ADDENDUM 1

T-12 IFB Derby Street Park, 289 Derby Street Salem, MA

Date: September 27, 2017

DATE: 09-15-2017 SCALE: 1" = 10' - 0" FILE: DSP-L4.0 Grading.dwg DWN BY: JHC, MNT

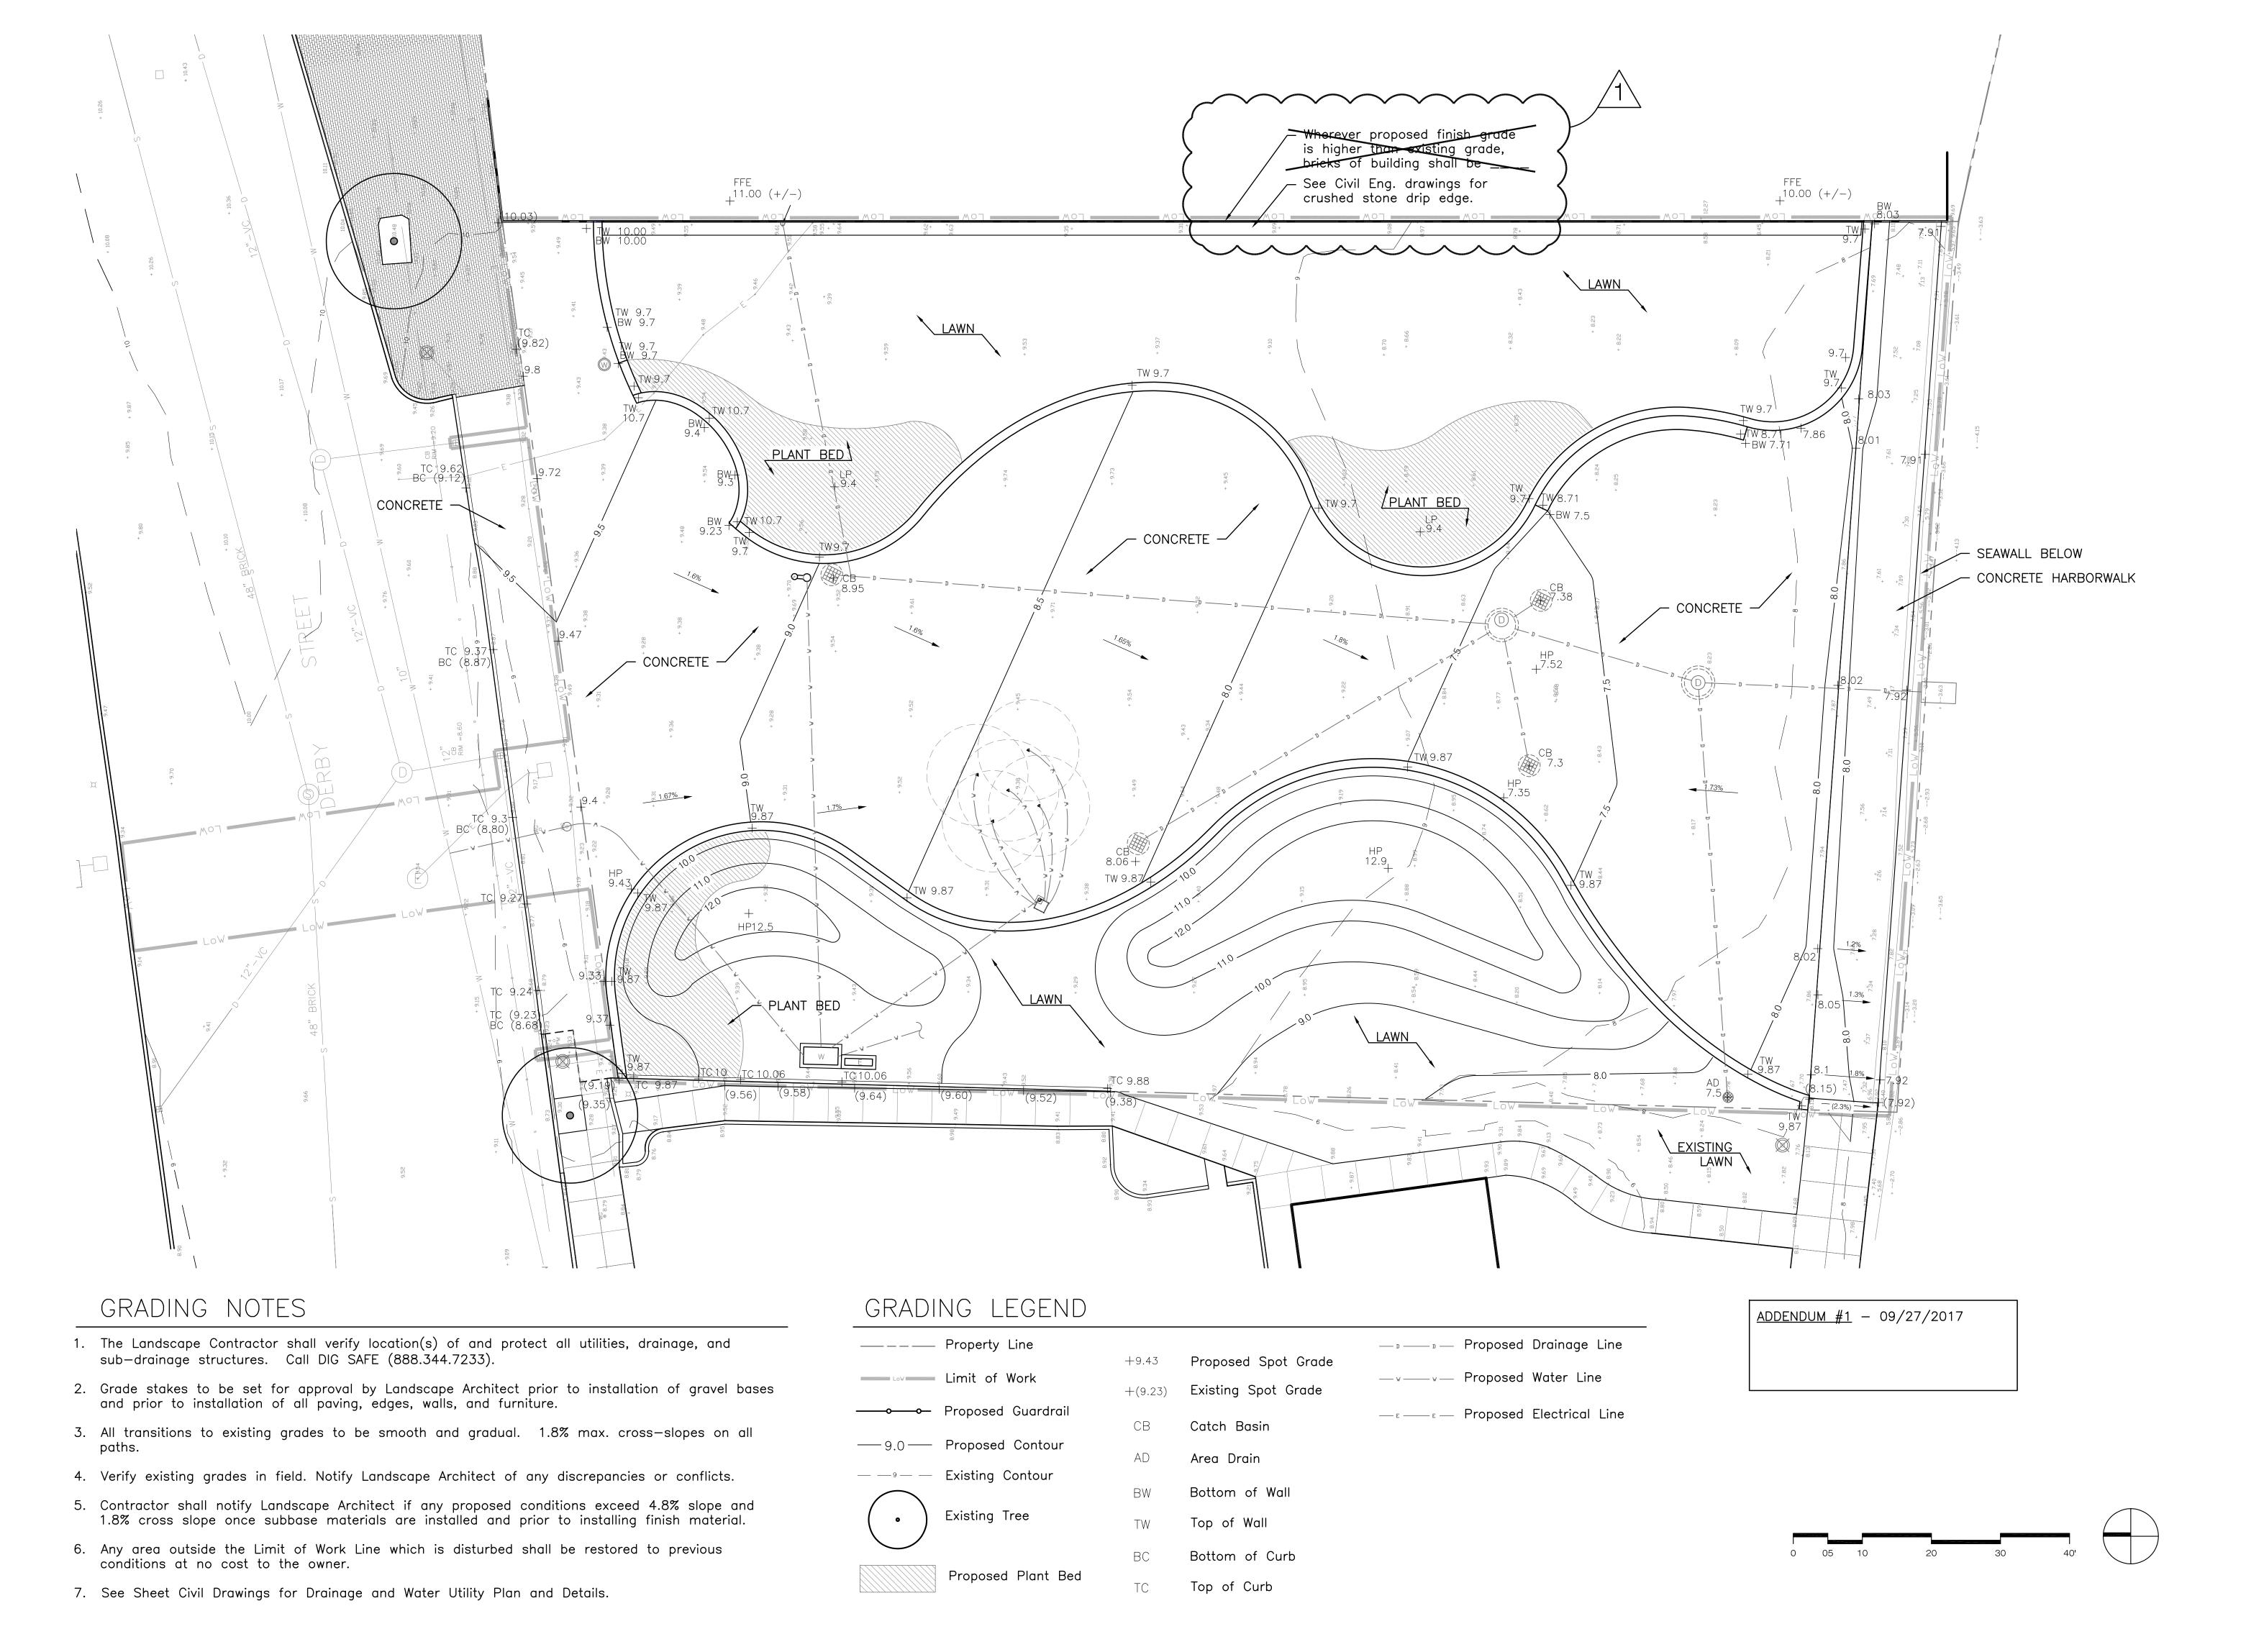
- 1) Bids are due Wednesday, October 11th at 2:00 PM.
- 2) Sheet L4.0 Grading is to be replaced with the attached sheet also titled L4.0, but containing a revision 1 cloud and notation.
- 3) Questions/Requests for Clarification on the Invitation For Bids are due to Yeimi Colon (ycolon@salem.com), Acting Purchasing Agent, by 10/04/2017.
- 4) The new water meter, as specified on Detail 1/L6.5 and specification section 33 10 00 Water Utilities, is to be provided at no charge by the City of Salem to the contractor, per the City of Salem's Engineering Department.
- 5) In reference to specification section 01 41 00 1.3, the fee for all required City permits will be waived.
- 6) Per specification section 03 30 00 2.8 Slump Limits, only number A.3 is applicable to this project.
